EASA	NOTIFICATION OF A PROPOSAL TO ISSUE AN AIRWORTHINESS DIRECTIVE
	<p>PAD No.: 13-118</p> <p>Date: 15 August 2013</p> <p>Note: This Proposed Airworthiness Directive (PAD) is issued by EASA, acting in accordance with Regulation (EC) No 216/2008 on behalf of the European Community, its Member States and of the European third countries that participate in the activities of EASA under Article 66 of that Regulation.</p>
<p>In accordance with the EASA Continuing Airworthiness Procedures, the Executive Director is proposing the issuance of an EASA Airworthiness Directive (AD), applicable to the aeronautical product(s) identified below. All interested persons may send their comments, referencing the PAD Number above, to the e-mail address specified in the 'Remarks' section, prior to the consultation closing date indicated.</p>	
Type Approval Holder's Name : AIRBUS	Type/Model designation(s) : A300, A300-600, A300-600ST and A310 aeroplanes

TCDS Numbers : France No. 145 and EASA.A.014	
Foreign AD : None	
Supersedure : This AD supersedes EASA AD 2011-0006 dated 17 January 2011.	
ATA 29	Hydraulic Power – Hydraulic Accumulator – Inspection / Replacement / Placards Installation
Manufacturer(s)

Appendix 1

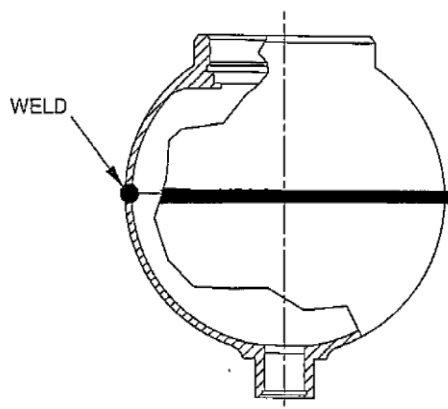
HYDRAULIC ACCUMULATOR : designed with 4 parts and 3 welds

OLD DESIGN

HYDRAULIC ACCUMULATOR : designed with 2 parts and 1 weld

NEW DESIGN
